PLANT NAME: NINE MILE PT. # 1

Re: Niagara Mohawk Power Corporation  
Nine Mile Point Nuclear Station,  
Unit No. 1  
Docket No. 50-220

APPLICATION FOR AMENDMENT  
TO  
OPERATING LICENSE

Proposed Change to Technical Specifications (Appendix A)

FIGURE 3.3.8

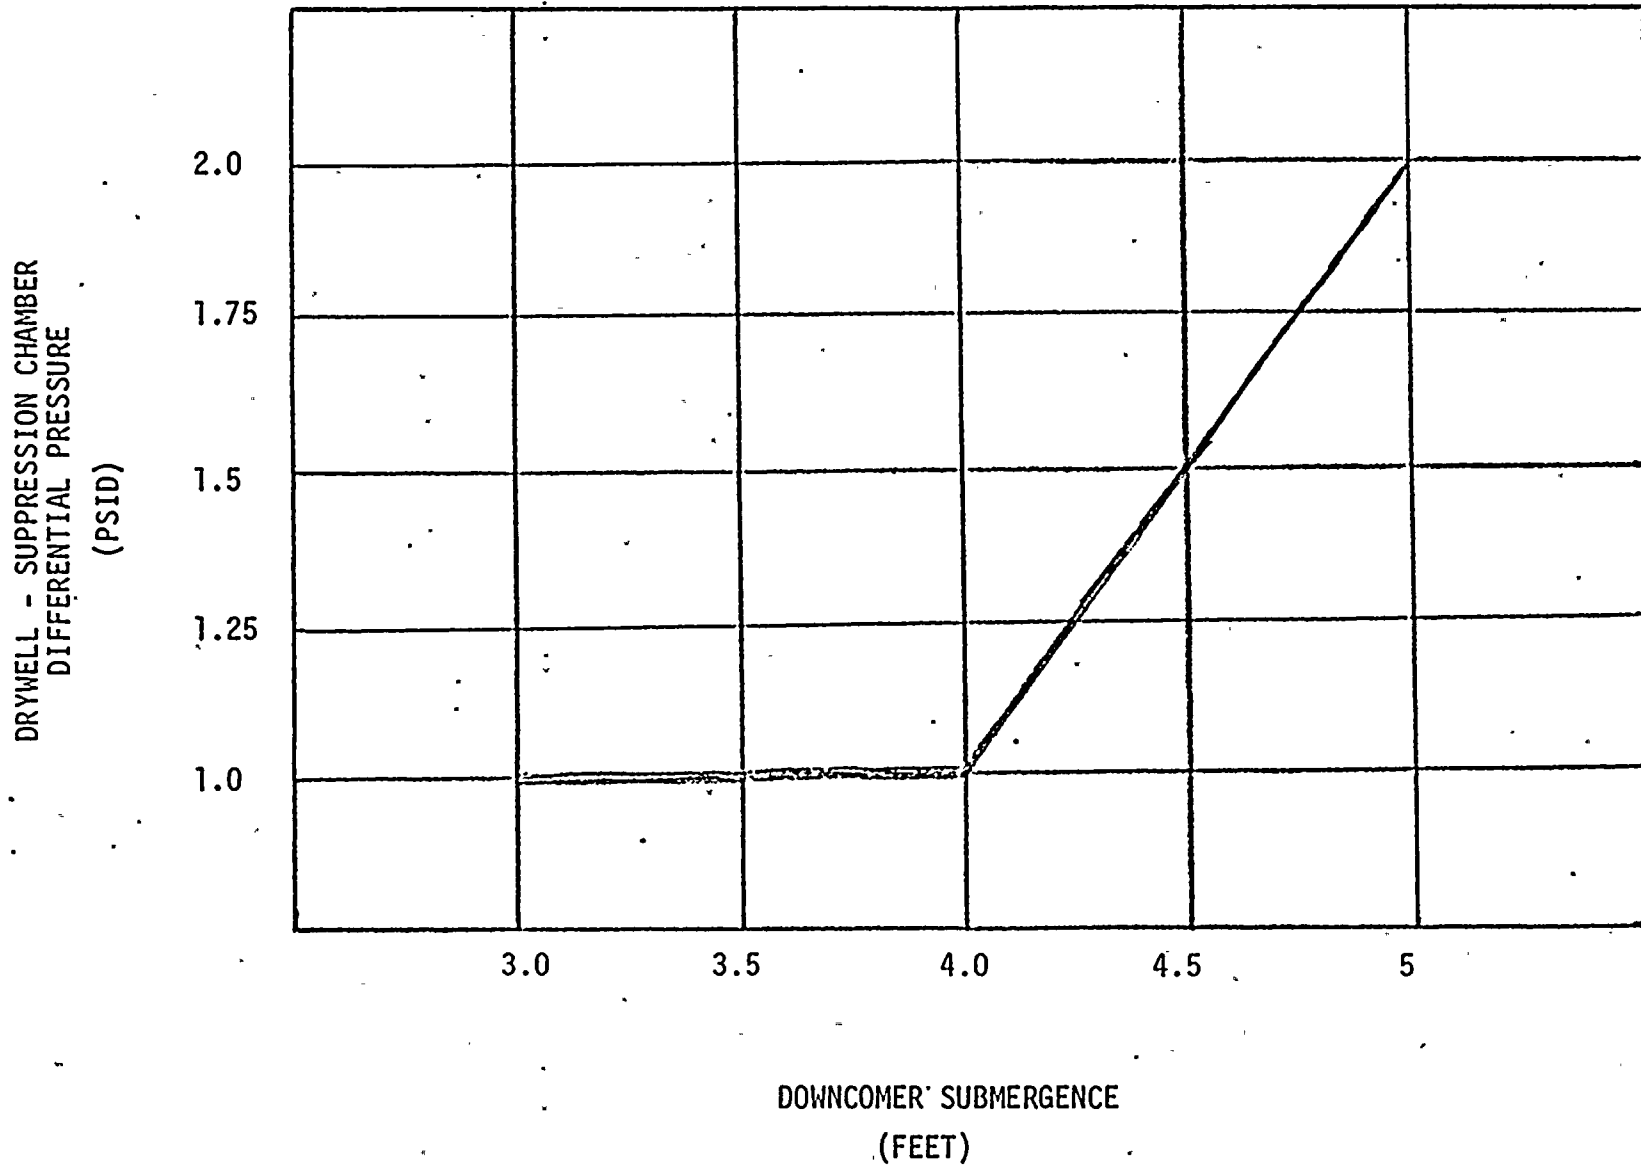
- a. Differential pressure between the drywell and suppression chamber shall be maintained according to Figure 3.7.1 except as specified in (1) and (2) below:
  - (1) This differential shall be established whenever containment inerting is required as specified by Specification 3.3.1.
  - (2) This differential may be decreased to less than that of Figure 3.7.1 for a maximum of four hours during required operability testing of the drywell-pressure suppression chamber vacuum breakers.
- b. If the differential pressure of Specification 3.7.1.a cannot be maintained, an orderly shutdown shall be initiated and the reactor shall be in the Hot Shutdown condition within 12 hours and the Cold Shutdown condition within the following 24 hours.

A drywell-suppression chamber differential pressure as shown in Figure 1 is being established to ensure that appropriate safety margins for the suppression chamber and its associated support structure are maintained following a Design Basis Loss of Coolant Accident.

FIGURE 1

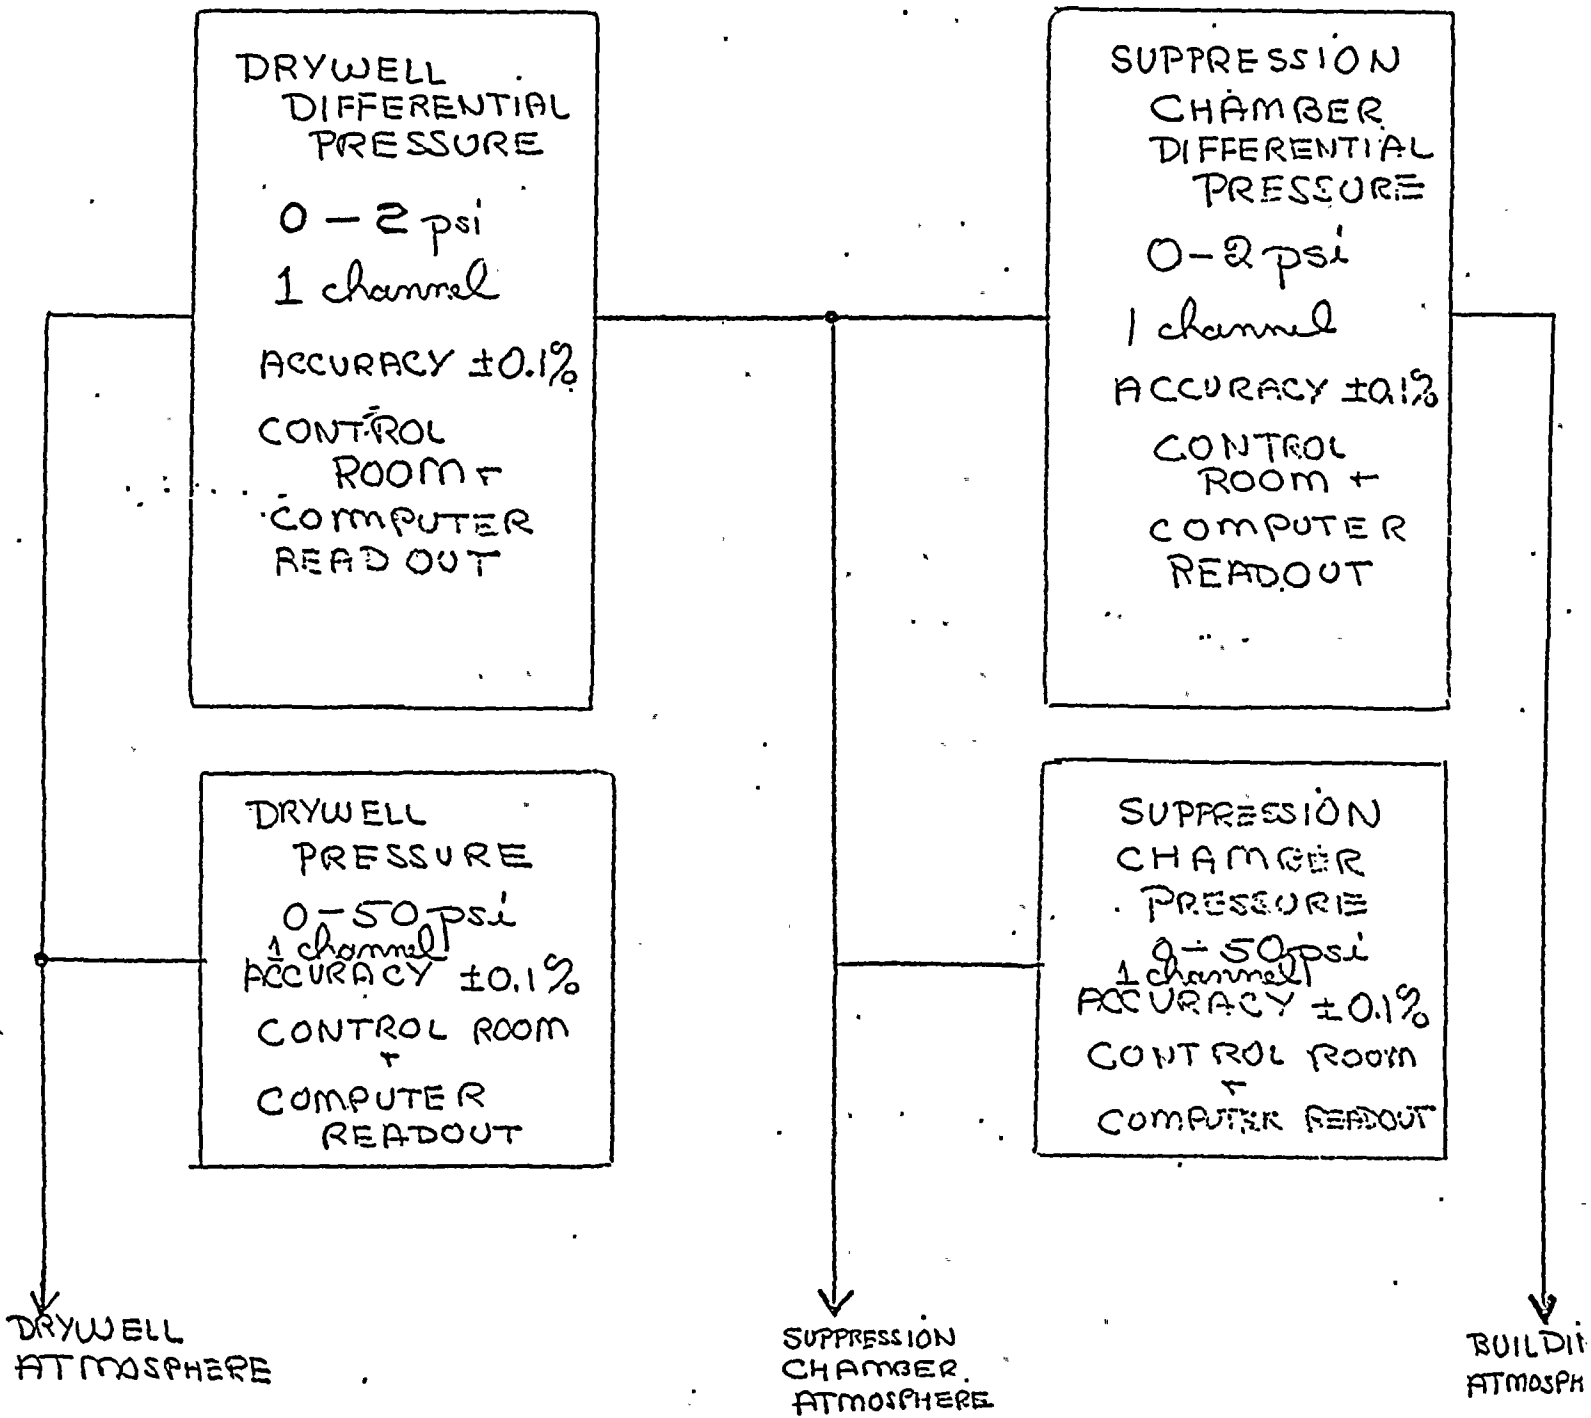
Figure 1 shows the instrumentation presently being used to monitor drywell-suppression chamber differential pressure. Included on the figure is range, accuracy, readouts and number of channels. Similar information for suppression chamber water level is shown in Figure 2. There are presently no Technical Specification requirements on this instrumentation nor are any proposed at this time. Should differential pressure be required at completion of the Long Term Program, Technical Specifications will be proposed for this instrumentation.
